The Mission of Teton Valley Trails and Pathways is to promote a trails and pathways connected community. Teton Valley Trails and Pathways has worked on trails in Teton Basin for all user groups for almost 25 years. In November of 2021 Trails and Pathways was awarded a Regional Forester Award for the Intermountain Region of the United States Forest Service. We were recognized for the partnership with the USFS and shared stewardship of the National Forest Lands. We look forward to extending that partnership to The Bureau of Land Management. Organizationally, our work focuses on the Teton Valley Basin and our comments will be specific to those zones only. We appreciate the opportunity to comment on the BLM proposed travel management plan for Southeast Idaho.

Comments to specific routes proposed on the [BLM Planning Map](#).

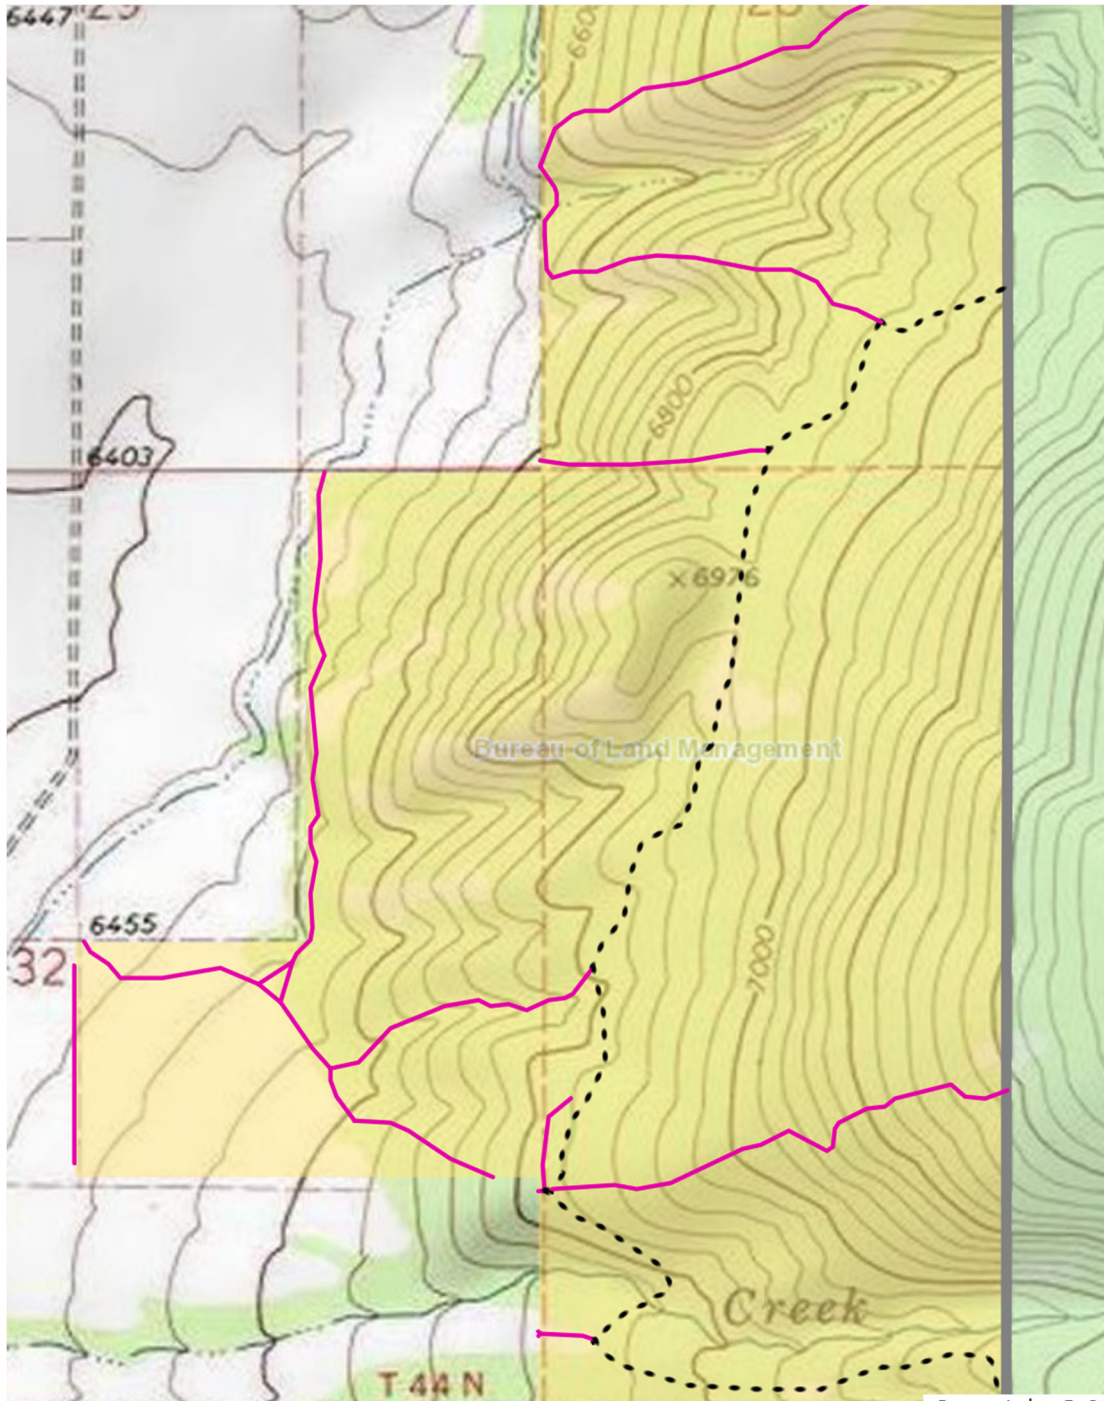
In the northern zone the access point at Coco Belle is managed by Wyoming Game and Fish. There is also a canal/water delivery system at the access that should be considered in planning. For this zone, we support a low volume of trails that will allow non-motorized users access to the Dead Cow Trail to the north and to Spring Creek/Aspen Trail to the South. There is historical use of both motorcycles and ATV's

UE 1458-This route exists as a multi-use two track route, runs adjacent to sections of a canal and is immediately adjacent to private property. This route should remain open as an access point for whatever uses the BLM deems appropriate.

UE 1459-This route is not in good shape and should be either closed and routed to UE 1458 OR rerouted and close UE 1458 to have a singular north/south connector.

UE 1453-This north south connector trail makes sense for the point-to-point trail alignment. One consideration would be to move trail alignment to the west and closer to the private parcels so it does not split habitat. For example, can the trail traverse closer to the 6800 Foot Contour Index line on the map.

UE 1400-This route should be closed as there is no access to the west from the Wyoming Game and Fish Parcel.

UE 1468-This route is historically multi-use but travels straight up the fall line and is in very poor shape. It should be closed OR if adopted for use, major re-routing will be needed to bring the tread to a more sustainable grade.

UE 1451-This route is also historically a multi-use two track and is in very poor shape. If it is adopted as non-motorized or multi-use, it will need significant re-routes to make a more sustainable trail.

UE 1470-Close this route as it has no public access point.

UE 1460-Close this route as it has no connectivity on USFS land.

UE 1492-This route should be adopted as a north/south route.

Comments to specific routes in the **Southern Zone**.

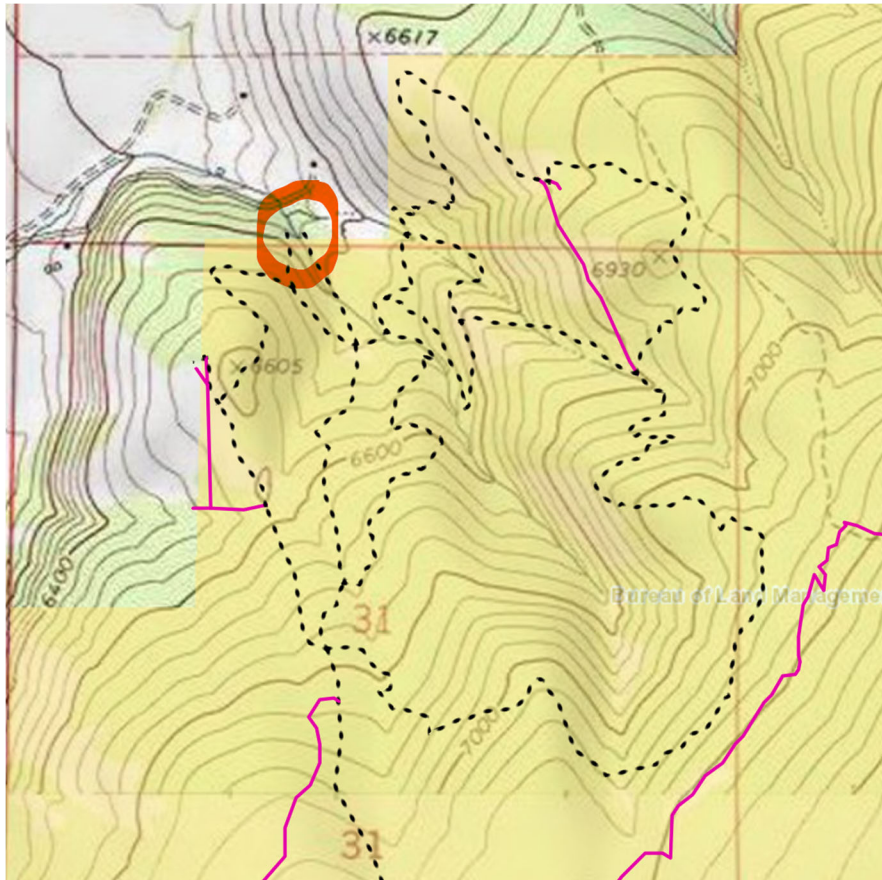
In this first screenshot of this area which is the far northern part, the orange circle indicated where several trails begin/end. If there is no area for the public to access the trails, we ask that a consideration be made to allow a non-motorized route to loop back south from trail UE 1409. We understand most of the trails in this area are outfitter trails and support the non-mechanized designation for almost all these trails. A return route along 1419 and 1416 that is non-motorized would allow users a loop from the Mud Lake area. If the outfitter ceases to exist in the future, and we hope they do not, adoption of a small fraction of these trails for public use should be considered.

Mud Lake Zone

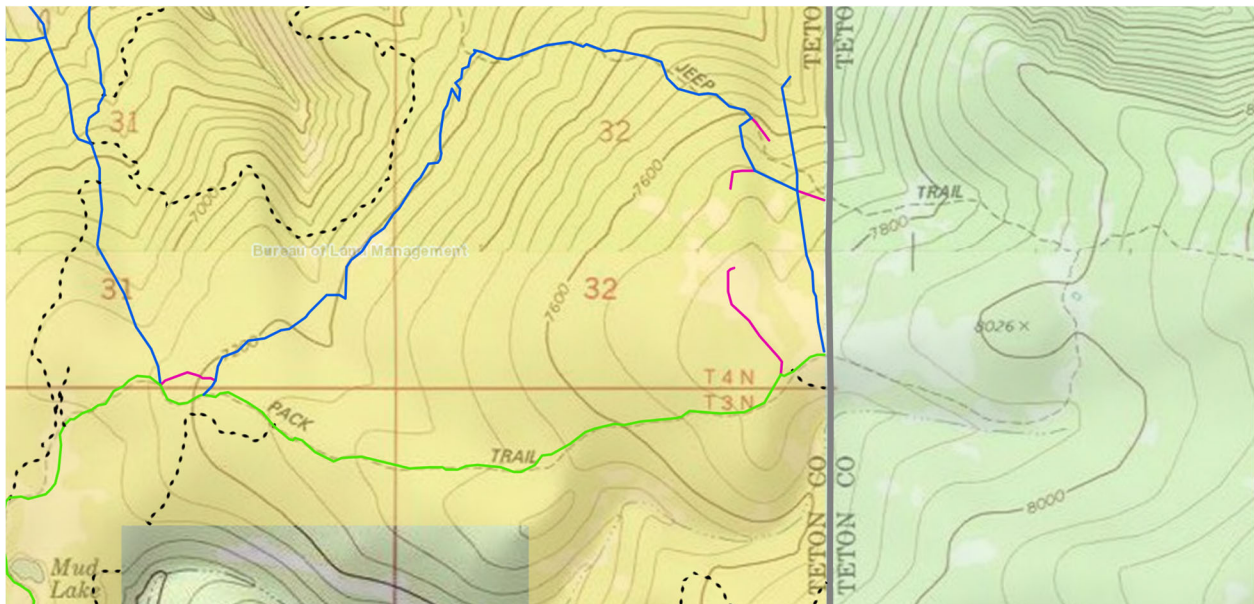
Historically, multi-use trails anchor this area. If trails are adopted for multi-use, we encourage planning a singular loop route using UE 1408 and UE 1411. Additionally, we encourage planning a non-motorized

route traveling south with the AJ trail being the southern end of the connection. Seasonal closures should also be enforced in this area.

Victor Zone

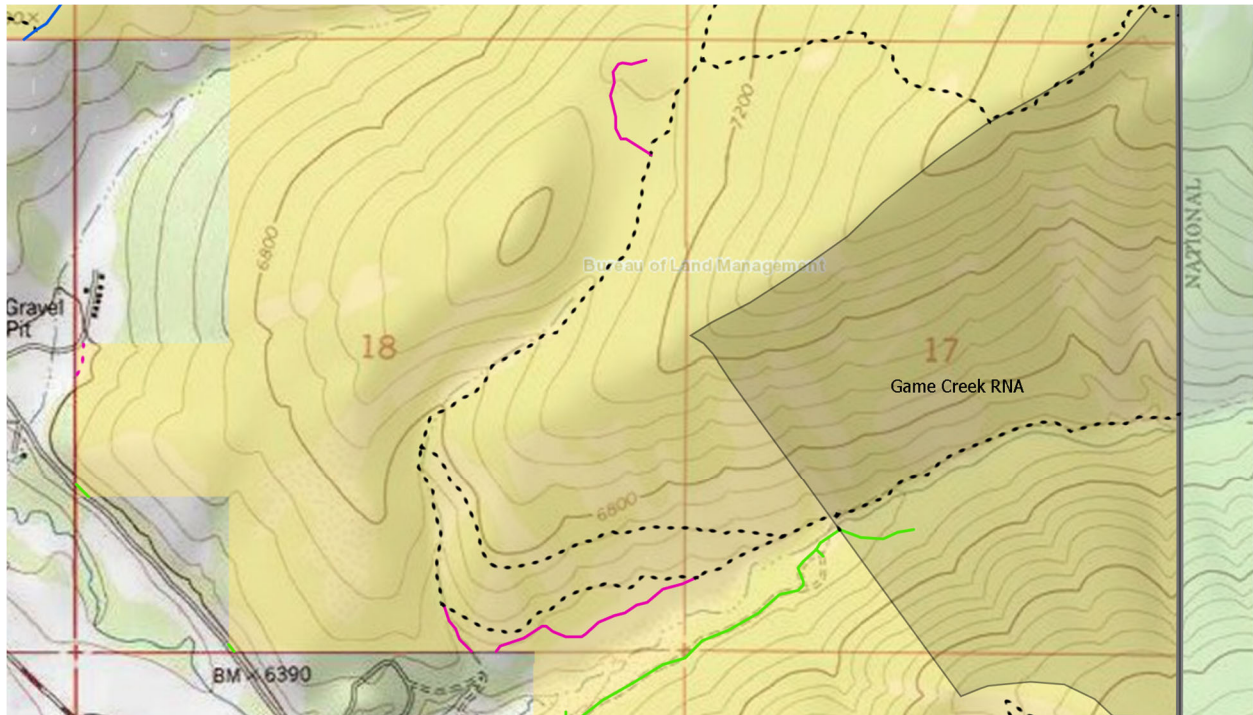
This zone has a high density of trails proposed and could be curtailed or planned better. We feel that connectors north to Mud Lake and South to Game Creek should be prioritized. Additionally, any non-motorized trails in this area should be planned to limit habitat segmentation by small loops, potentially closer to areas of impact like the public/private lands interface. If the multi-use route, UE 1429 has contiguous routes on the forest and/or access from another public access then it makes sense to keep open, if it does not have those connections, it does not make sense to open. This area has a lot of potential for high volume use with proximity to Victor and surrounding subdivisions. Directional trails for the loops should be strongly considered.
